Access Compliance Report

Public Rights-of-Way

(Curb Ramps)

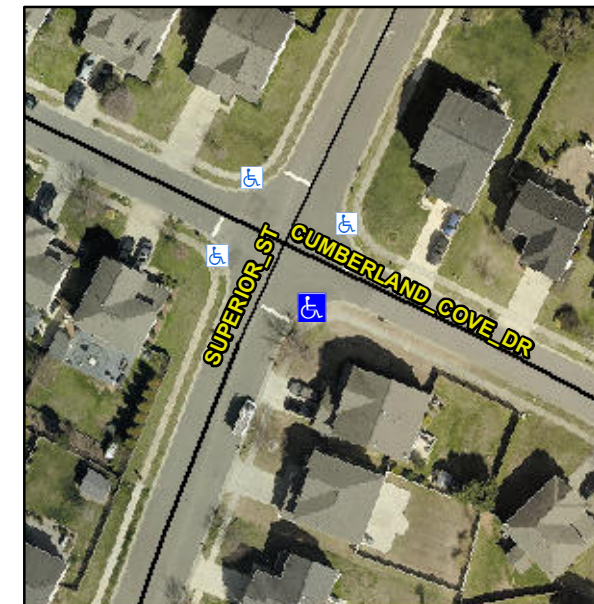
Intersection ID: 46758	Main Street: CUMBERLAND_COVE_DR	Cross Street: SUPERIOR_ST	Location: SE
ADA ID: 2BC4062F2EA1	Ramp Type: PerpDiag	Initial Pass/Fail: Fail	Overall Compliance: No
Severity Score: 22.5			
Codes/Mitigation Info/Possible Solution		Field Measurements/Component Compliance

R304.5.1, R304.2.2, R304.5.3

Compliance	Description	Data	Compliance	Description	Data
N/A	Ramp Length (in)	48.0	No	Ramp Slope (%)	11.8
No	Ramp Width (in)	43.0	No	Ramp XSlope (%)	3.1
N/A	Flare Type LT	N/A	N/A	Flare Type RT	N/A
N/A	Flare Slope LT (%)	N/A	N/A	Flare Slope RT (%)	N/A
N/A	Flare Traversable LT?	N/A	N/A	Flare Traversable RT?	N/A
N/A	Landing Length (in)	N/A	N/A	DWS Provided?	N/A
N/A	Landing Width (in)	N/A	N/A	DWS Contrast?	N/A
N/A	Landing Slope (%)	N/A	N/A	DWS Length (in)	N/A
N/A	Landing X Slope (%)	N/A	N/A	DWS Full Width?	N/A
N/A	Landing Curb? (Y/N)	N/A	N/A	DWS Offset (in)	N/A
N/A	Shared Landing?	N/A			
N/A	Gutter Ponding?	N/A	N/A	Gutter Slope (%)	N/A
N/A	Gutter Lip Ht (in)	N/A	N/A	Gutter X Slope (%)	N/A
N/A	Painted X Walk1?	No	N/A	Painted X Walk2?	No
	X Walk 1 Direction	To NE		X Walk 2 Direction	To NW
N/A	X Walk 1 Width (in)	N/A	N/A	X Walk 2 Width (in)	N/A
	X Walk 1 Slope (%)	4.3		X Walk 2 Slope (%)	2.1
	X Walk 1 X Slope (%)	2.2		X Walk 2 X Slope (%)	4.4

Remove & Replace Curb Ramp With Two New Directional Ramps or Equivalent.
